UNITED STATES PATENT AND TRADEMARK OFFICE

APPLICATION NO.	FILING DATE	FIRST NAMED INVENTOR	ATTORNEY DOCKET NO.	CONFIRMATION NO.
10/705,899	11/13/2003	Joun Ho Lee	8733.275.20-US	6109

Office Action Summary	Application No. 10/705,899	Applicant(s) LEE ET AL.	
	Examiner HOAN C. NGUYEN	Art Unit 2871

DETAILED ACTION

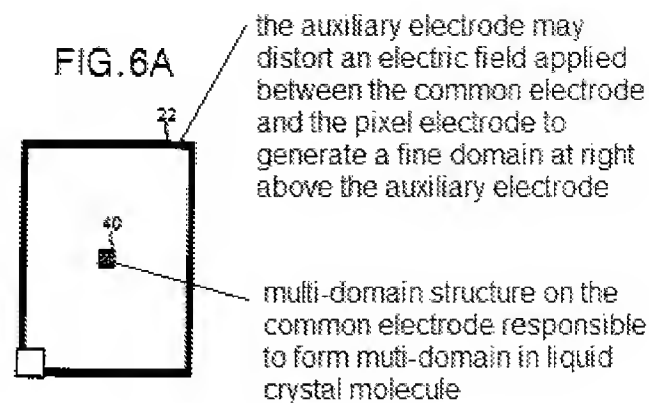
The drawings are objected to under 37 CFR 1.83(a). The drawings must show every feature of the invention specified in the claims. Therefore, the combination of "each pixel region has a multi-domain structure which includes a dielectric structure or slit" and "the common electrode includes an opening area" to form the multi-domain in claim 1 must be shown or the feature(s) canceled from the claim(s). No new matter should be entered.

In the light of the specification, the opening area in the common electrode should form the multi-domain structure. However, although the auxiliary electrode line takes advantage of the gate signal applied to the gate lines, the auxiliary electrode line by itself cannot form the multi-domain without combining with the multi-domain structure (opening) in common electrode. The auxiliary electrode line takes advantage of the gate signal applied to the gate lines would cause the disturbance of liquid crystal molecules because the auxiliary electrode may distort an electric field applied between the common electrode and the pixel electrode to generate a fine domain at right above the auxiliary electrode as shown in Fig. 6A below:

Corrected drawing sheets in compliance with 37 CFR 1.121(d) are required in reply to the Office action to avoid abandonment of the application. Any amended replacement drawing sheet should include all of the figures appearing on the immediate

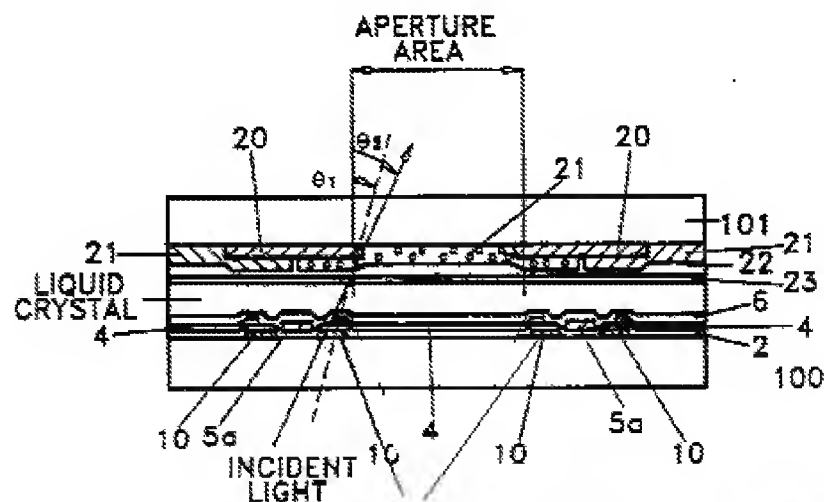
In the same way, the applied reference Kim et al. (US5767926A) discloses the auxiliary electrode line 10 takes advantage of the gate signal applied to the gate lines would cause the disturbance of liquid crystal molecules because the auxiliary electrode may distort an electric field applied between the common electrode and the pixel electrode to generate a fine domain at right above the auxiliary electrode as shown in Fig. 8 below:

The auxiliary electrode line takes advantage of the gate signal applied to the gate lines would cause the disturbance of liquid crystal molecules because the auxiliary electrode may distort an electric field applied between the common electrode and the pixel electrode to generate a fine domain at right above the auxiliary electrode

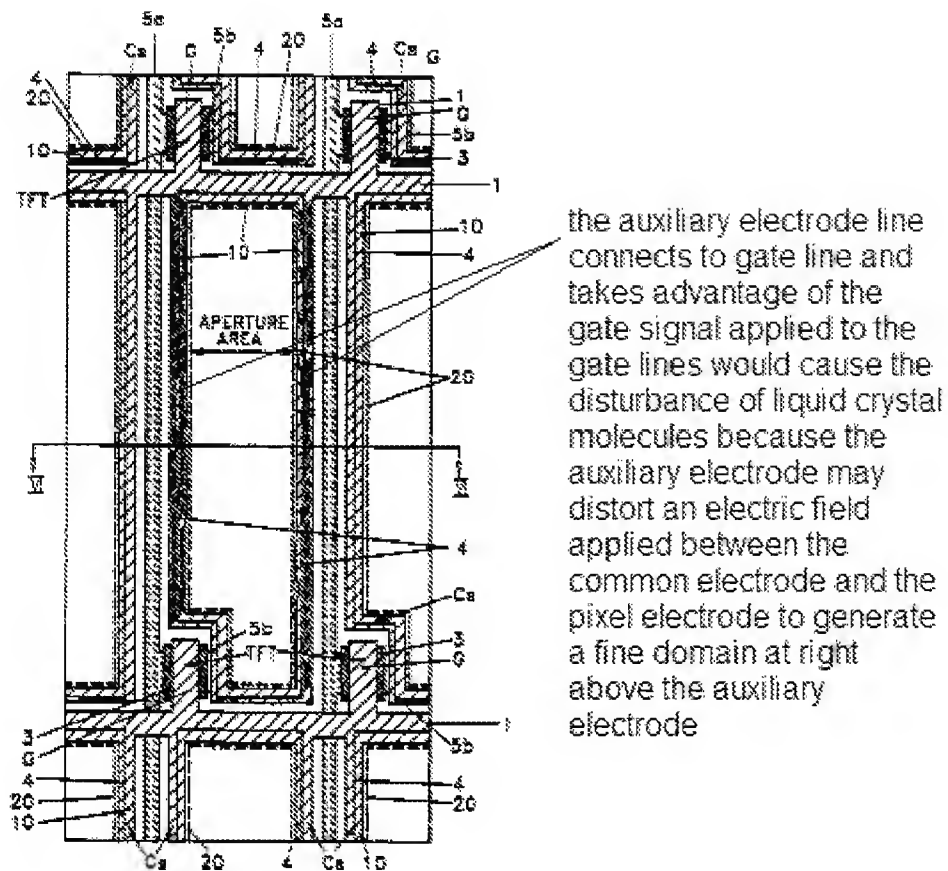
In regard to claim 1, Kim et al. disclose (Figs. 3G-J) a multi-domain liquid crystal display device comprising:

- first and second substrates ;
- a liquid crystal layer between the first and second substrates;
- a plurality of data lines 5a for applying a data signal on the first substrate;
- a plurality of gate lines 1 for applying a gate signal, the gate lines crossing the data lines to define a plurality of pixel regions,
- a thin film transistor near each crossing of the gate lines and the data lines;
- a common electrode 17 on the second substrate;
- a pixel electrode 13 connected to a drain electrode of the thin film transistor in each pixel region; and
- an auxiliary electrode line 10 electrically connected to at least one of the common lines in each pixel region,

- the auxiliary electrode line is formed between the pixel electrode and the data line at an outside of the pixel electrode in the pixel region and the auxiliary electrode is not overlapped with the data line.
- the auxiliary electrode line inherently takes advantage of the gate signal applied to the gate lines.
